REFERENCE LHC-TC-EC-0014

Date: 2018-04-05

ENGINEERING CHANGE REQUEST

First Phase of Installation of Low-Impedance Secondary Collimators (TCSPM) in IR7

Figure 1 — 3D view [5] of the TCSPM collimator, showing an extremity of the jaw with the embedded BPM, the “third” BPM for orbit measurements in the plane orthogonal to the collimation plane, and the new tapered transitions made of MoGr.

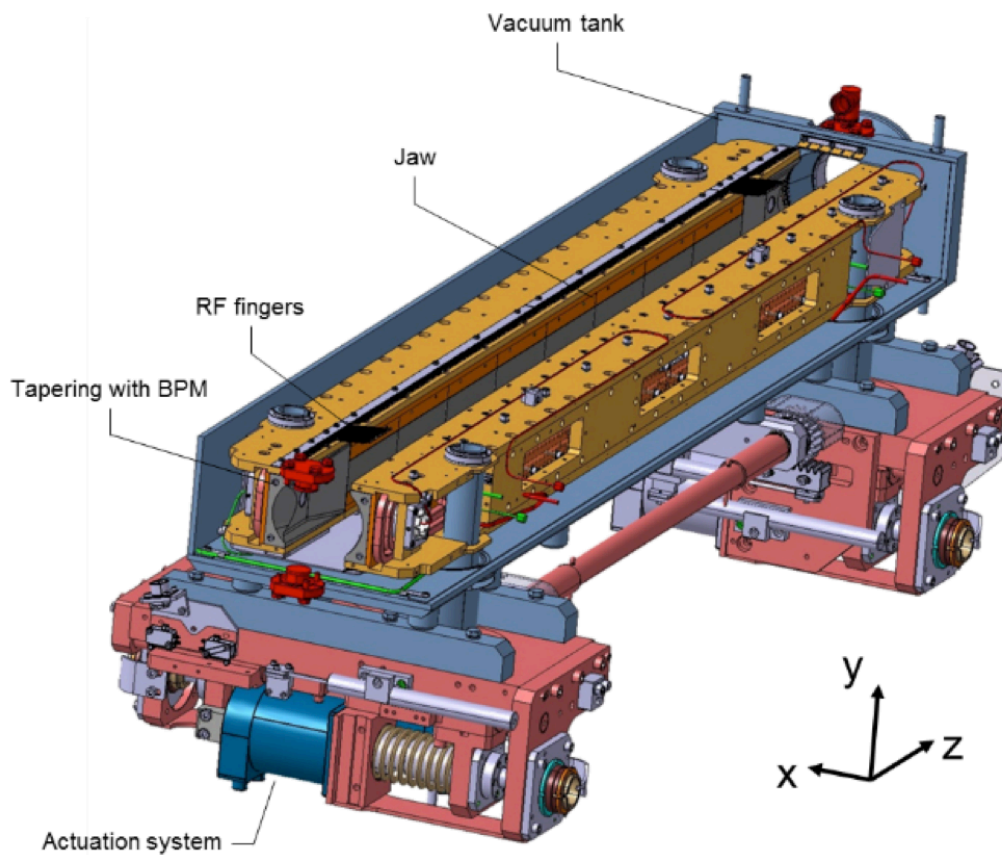
The present TCSPM design [5] (see Figure 1) is an evolution of the present TCSGs [1]; among the most noticeable differences, there are material and coating of the jaw, and the presence of Beam Position Monitors (BPMs). The BPMs are embedded in the jaw and shall be added in the database with the same notations used for the present TCTP and TCSP collimators. Other features are described in [7]. In fact, the design foresees jaws made of a composite material (MoGr) obtained from Molybdenum and graphite, chosen for its similar robustness and superior impedance characteristics with respect to the jaw material of the present TCSGs, in particular since a thin coating layer of Mo will be deployed. The collimator jaws are equipped with BPM button pick-ups, for an easy determination of the beam closed orbit at the collimator and fast and precise alignment of the jaws. A third BPM is installed on the tank, to measure the beam position on the axis orthogonal to the one of cleaning.
